Sundry Print Report

Well Name: CORRAL 22-34 FED COM

Well Number: 106H

Type of Action: APD Change

C-102
Revised July 9, 2024
Submit Electronically via OCD Permitting

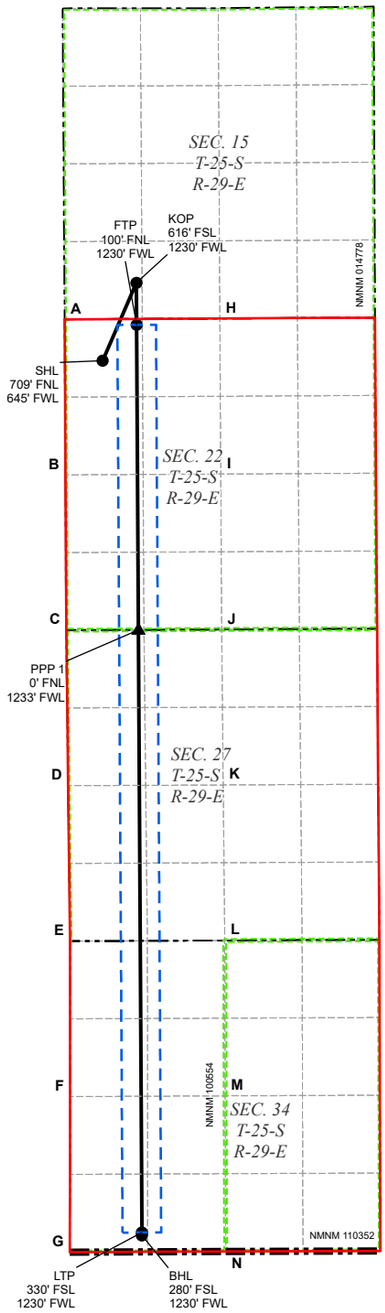
XTO Energy Inc. respectfully requests approval to make the following changes to the approved APD. Changes include KOP, FTP, LTP, BHL, Proposed total depth, Formation TVD, Casing Design, Cementing Program, Mud Program.
APD ID 10400098653; Well API : 30-015-56556

KOP: 709' FNL & 645' FWL OF SECTION 22-T25S-R29E 616' FSL & 1230' FWL OF SECTION 15-T25S-R29E
FTP: 100' FNL & 1170' FWL OF SECTION 22-T25S-R29E 100' FNL & 1230' FWL OF SECTION 22-T25S-R29E
LTP: 330' FSL & 1170' FWL OF SECTION 34-T25S-R29E 330' FSL & 1230' FWL OF SECTION 34-T25S-R29E
BHL: 50' FSL & 1170' FWL OF SECTION 34-T25S-R29E 280' FSL & 1230' FWL OF SECTION 34-T25S-R29E

The proposed total depth is changing from 26874 MD; 10425 TVD to 27279 MD; 11076 TVD.
